1984 Corvette: Recall: Positive Battery Cable Routing

Subject: Product Safety Campaign 84C04 Positive Battery Cable Routing

Number: 84C04, Number XII

Date: August, 1983

Figure 1

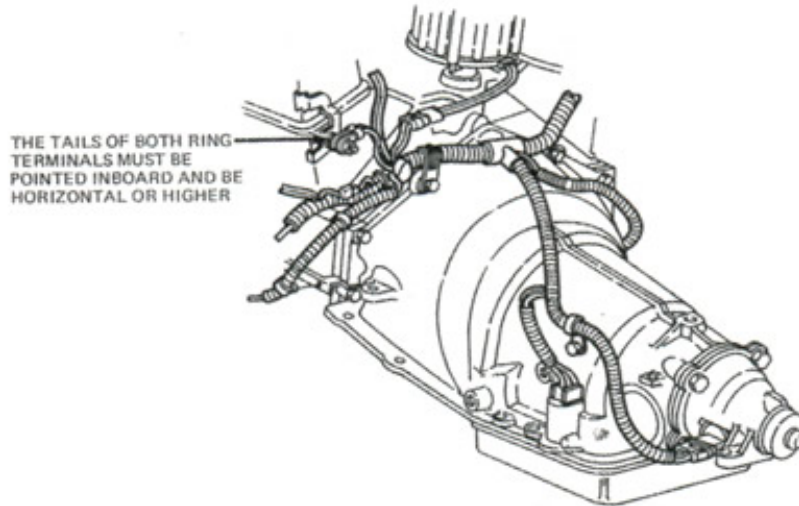
4. Loosen the ground stud nut on the left hand rear cylinder head and reposition both (2) ground wire ring terminals. Terminals are to point inboard and be horizontal or higher. (Figure 1)
5. Thread the kit supplied conduit over the positive battery cable. The inboard end of the conduit should extend inboard beyond the (ground stud) repositioned ground ring terminals.

Figure 2

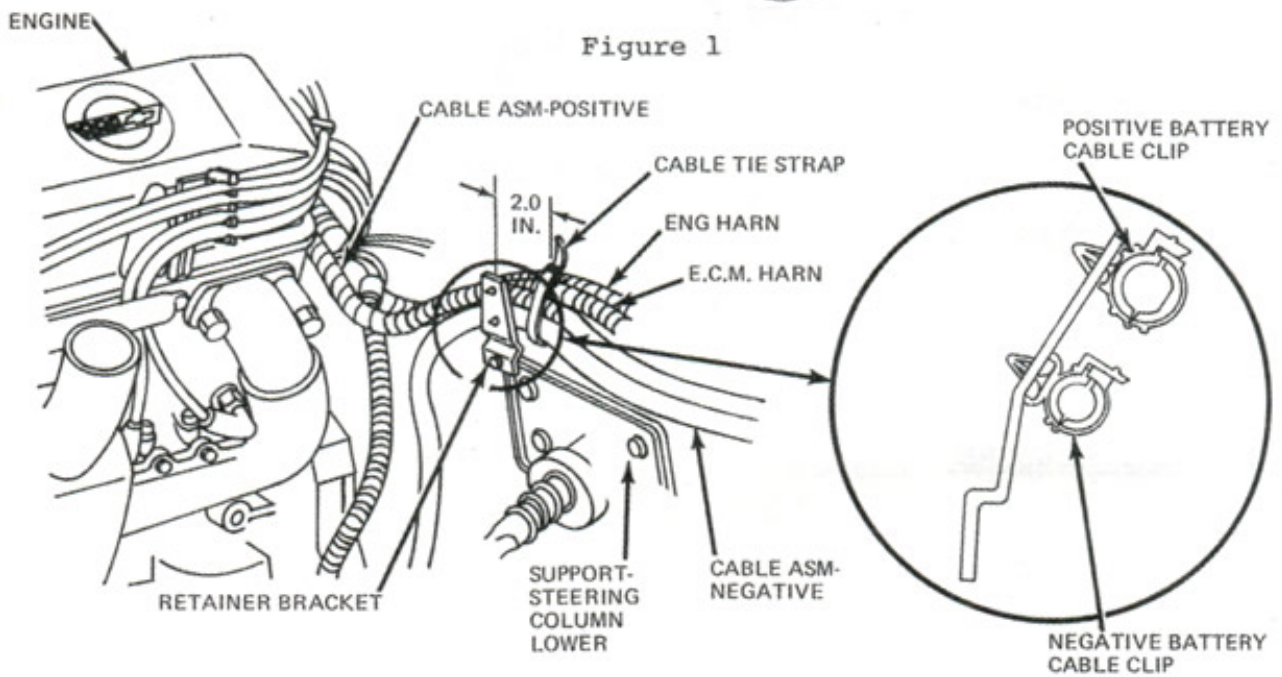
6. Install the supplied conduit clips on supplied bracket. The larger inside diameter clip in the top hole and the smaller in the lower hole. Both battery cables must be routed on the rear side of the new harness bracket. (Figure 2)
7. Align bracket to stud or attaching bolt hole and lock lower clip to negative battery cable. Lock upper clip to conduit on the positive battery cable.

THE UPPER (POSITIVE) CABLE CLIP IS TO BE LOCATED AND LOCKED 51MM (2.0 IN.) INBOARD FROM THE OUTBOARD END OF THE CONDUIT. (FIGURE 2)
